Radio Frequency Analysis Report

Site MA-4388

196 West Street
Paxton, MA 01612

May 9, 2014

Exhibit 2: AT&T Existing 3G Coverage (850 and 1900 MHz UMTS Overlay)

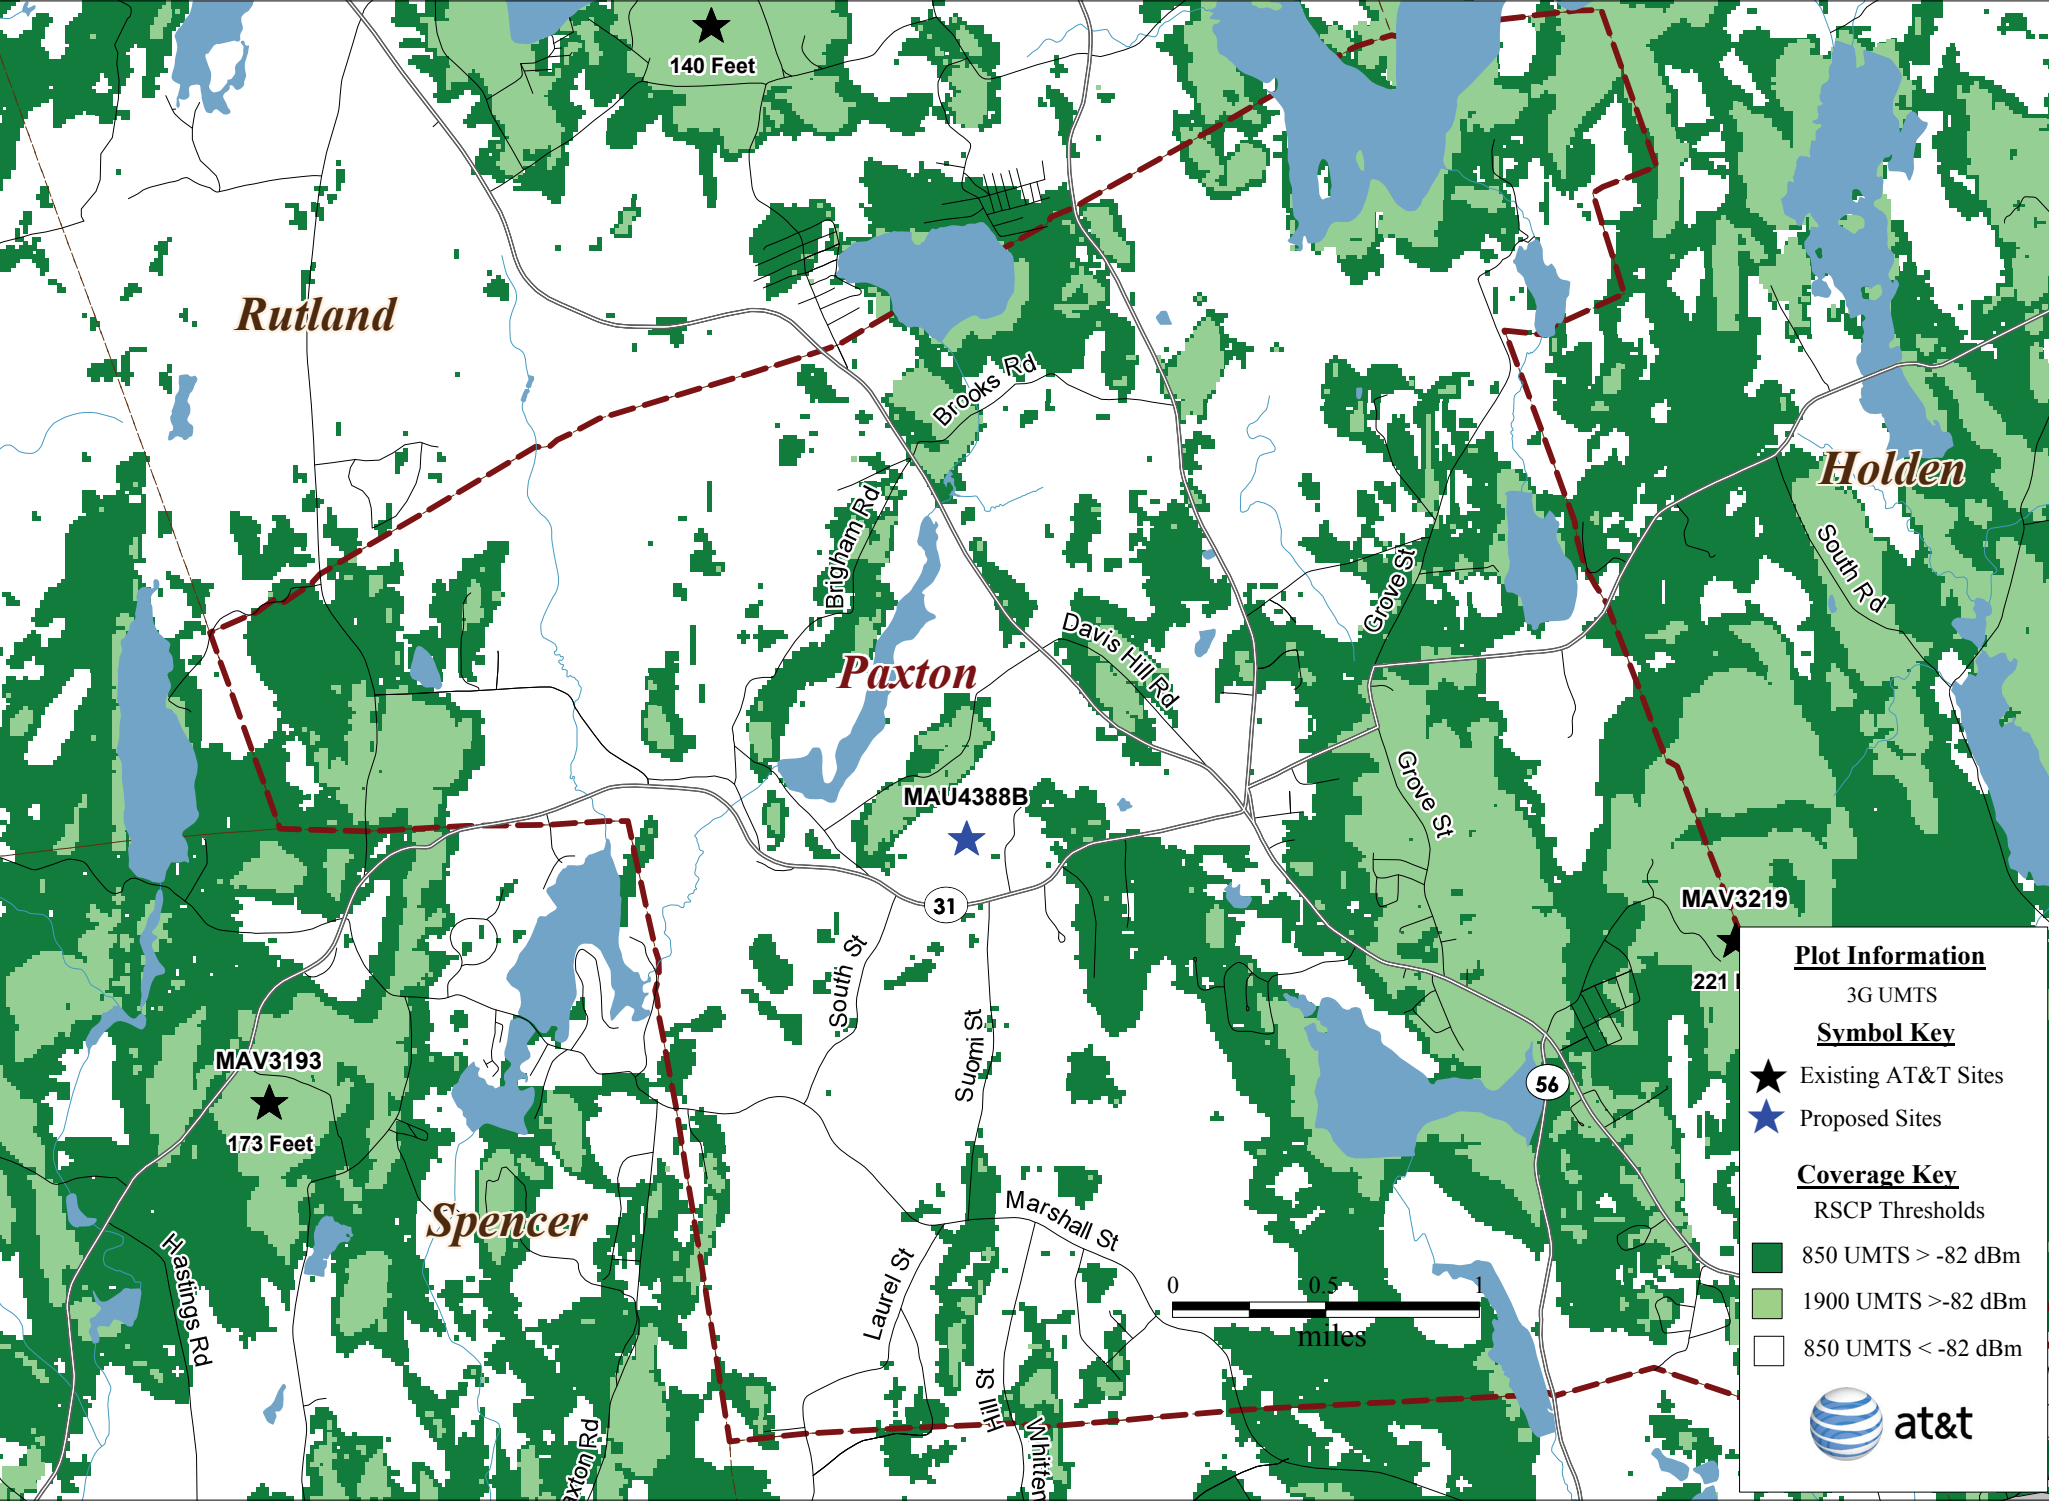
- Exhibit 2 – The prior Exhibit 2 was provided to depict AT&T’s existing network coverage in a format consistent with the other exhibits included with C Squared’s March Report. As noted in Mr. Graiff’s comments, the coverage plot provided depicted the coverage for UMTS services but was labeled with the LTE coverage thresholds. C Squared has confirmed that the coverage plot presented was prepared using the correct coverage threshold for AT&T’s UMTS coverage, but was mislabeled with the LTE coverage thresholds. In order to avoid any confusion, C Squared has revised Exhibit 2 to depict the existing UMTS coverage with correct UMTS coverage threshold (-82 dBm).
